AGENDA
FOR THE CITY OF OLIVETTE
PLANNING AND COMMUNITY DESIGN COMMISSION
MEETING OF APRIL 21, 2016
AT 7:00 PM
IN THE OLIVETTE CITY COUNCIL CHAMBERS
AT CITY HALL GOVERNMENT CENTER
LOCATED AT 9473 OLIVE BOULEVARD

DATE: APRIL 21, 2016
TO: PLANNING AND COMMUNITY DESIGN COMMISSION
FROM: CARLOS TREJO, AICP
DIRECTOR OF PLANNING AND COMMUNITY DEVELOPMENT
RE: 4 DOWNEY LANE
PETITION FOR COMMUNITY DESIGN REVIEW

DATE: APRIL 21, 2016
TO: PLANNING AND COMMUNITY DESIGN COMMISSION
FROM: CARLOS TREJO, AICP
 DIRECTOR OF PLANNING AND COMMUNITY DEVELOPMENT
RE: 9761 LINDLEY DRIVE
 PETITION FOR COMMUNITY DESIGN REVIEW & SITE PLAN REVIEW

DATE: APRIL 21, 2016
TO: PLANNING AND COMMUNITY DESIGN COMMISSION
FROM: CARLOS TREJO, AICP
DIRECTOR OF PLANNING AND COMMUNITY DEVELOPMENT
RE: 20 BEVERLY DRIVE
PETITION FOR COMMUNITY DESIGN REVIEW & SITE PLAN REVIEW

SITE PLAN
SCALE: 1" = 20'

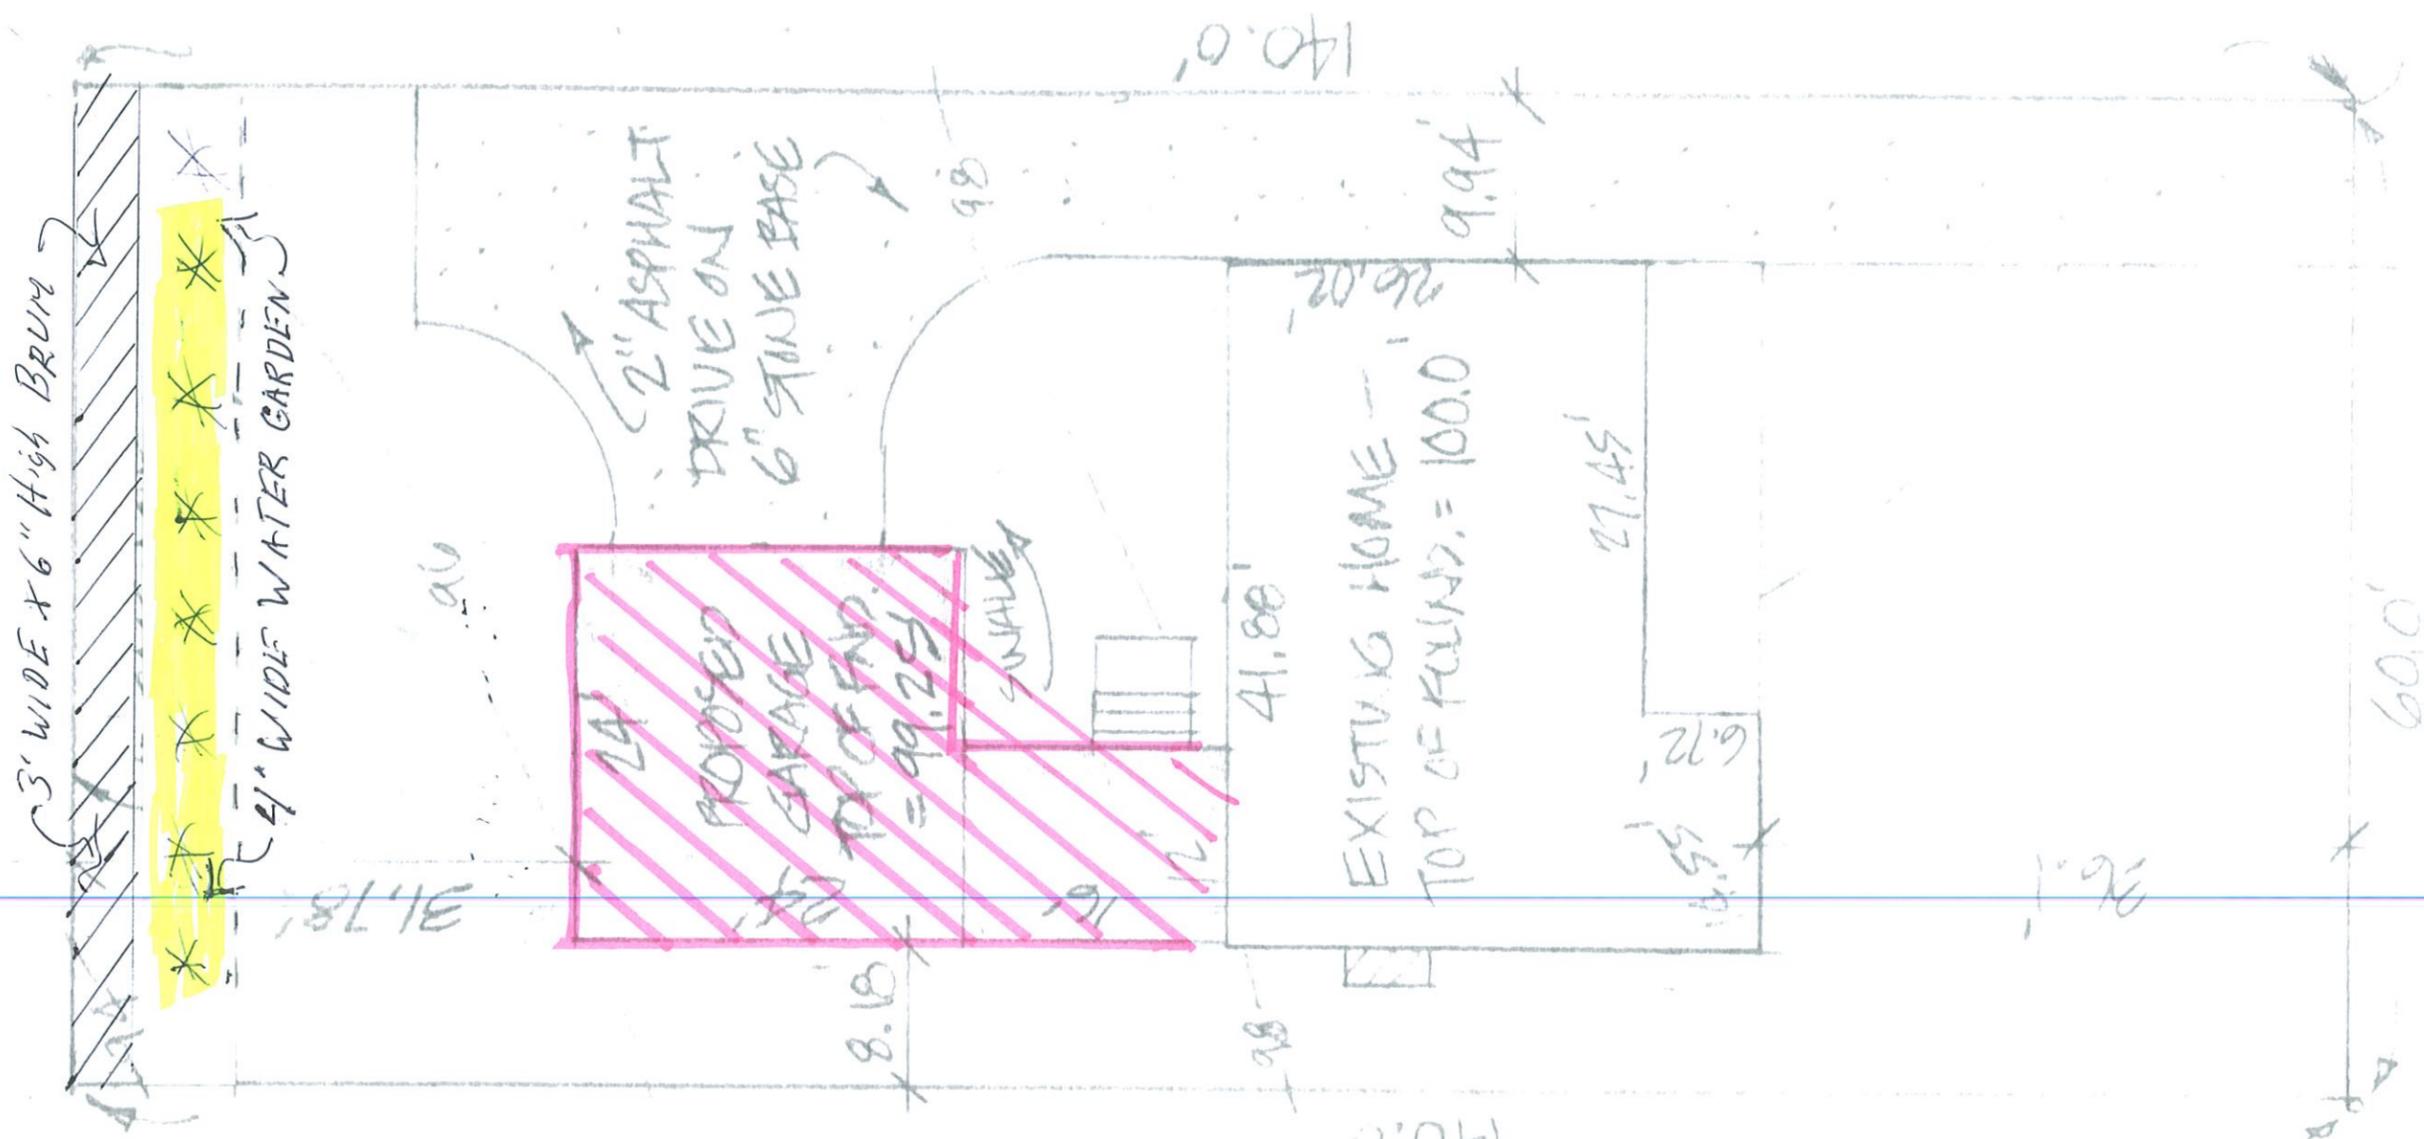
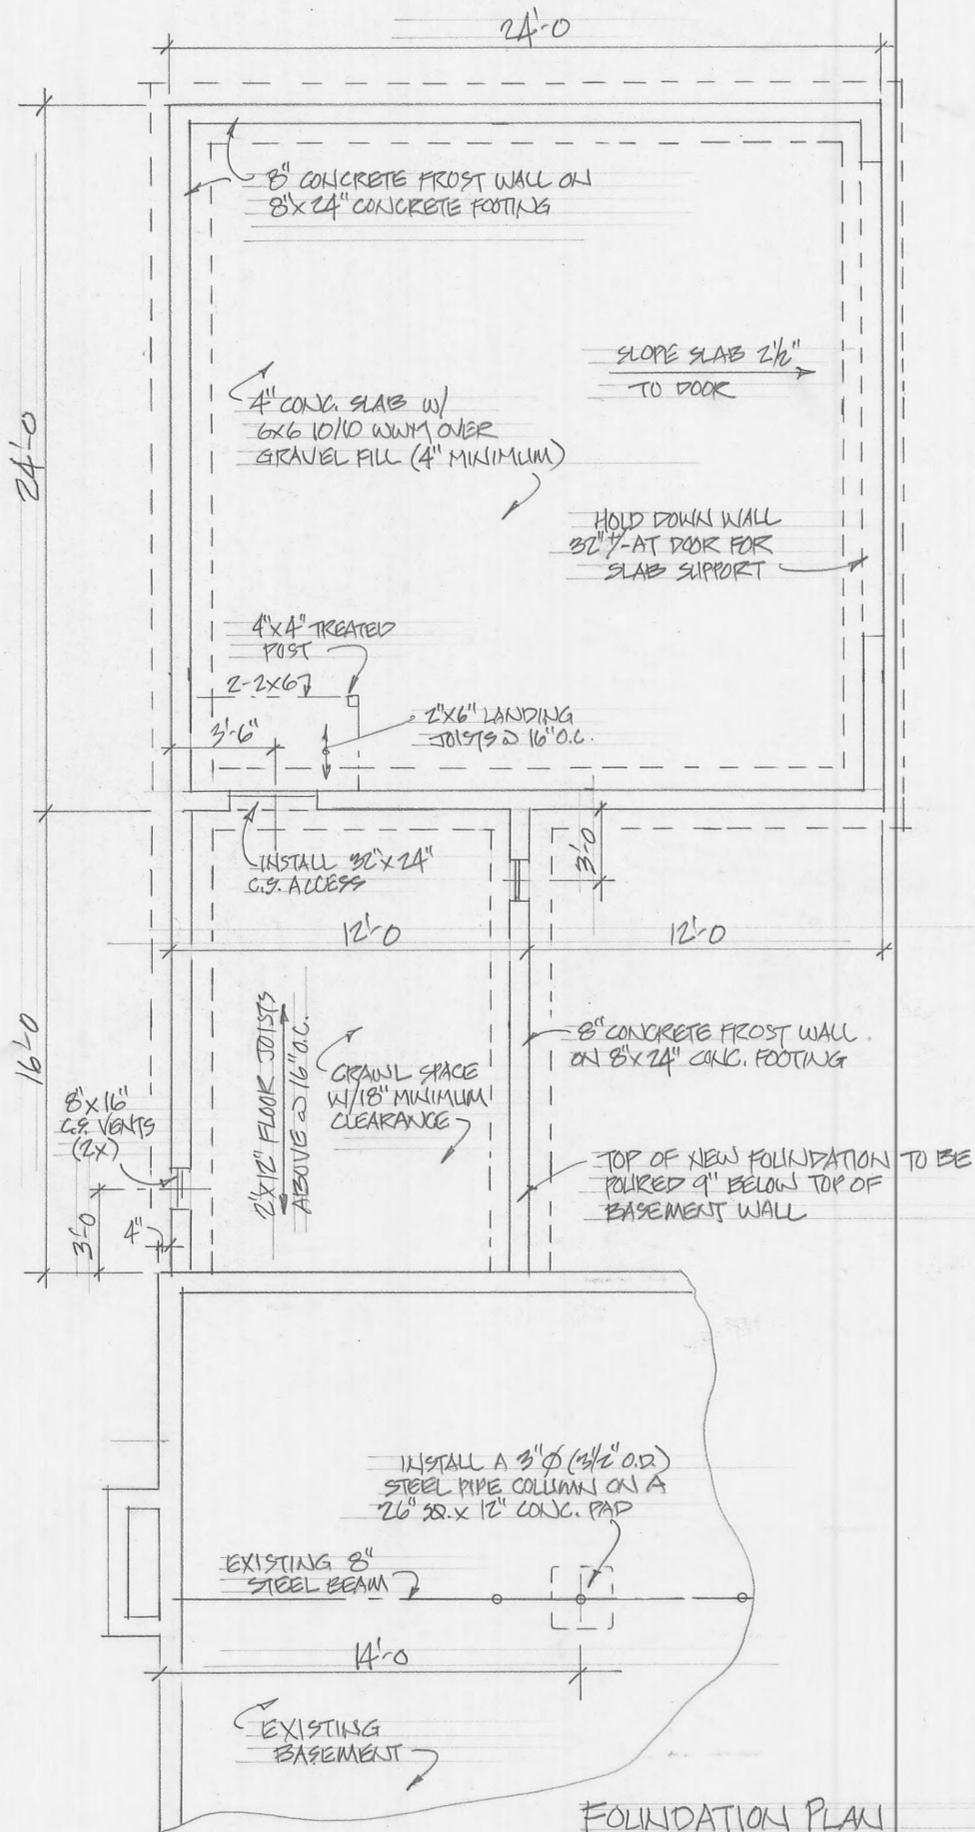
Staff has calculated the impervious area will be reduced by approximately 130 sf. Runoff will no longer sheet flow over the rear lawn as the garage will be placed within the buildable area of the rear yard. The driveway will no longer extend to the rear property line. As Stormwater generation areas are proposed to be modified, Stormwater drainage will continue to move to the rear of the property and will exit beneath the existing fence.

- Shallow water garden feature 4-feet wide. The depth has not yet been provided.
- Berm in front of the fence placed along the rear property line, 3-feet wide by 6-inches in height.
- Plant specifications have not been provided at this time.

1. Staff assist the Petitioner in the development of the site grading to implement the Stormwater detention area at the subject property
2. Report the final design to the Commission within 90-days from Commission approval.
3. The plans submitted for Building Permit review and construction shall be in conformance with the design, details, and dimensions illustrated in the plans and elevations outlined in the petition application, appearing before the Commission on April 21, 2016, containing a Site Plan and architectural drawings prepared by Martin Designs, with a revised date of February 29, 2016.
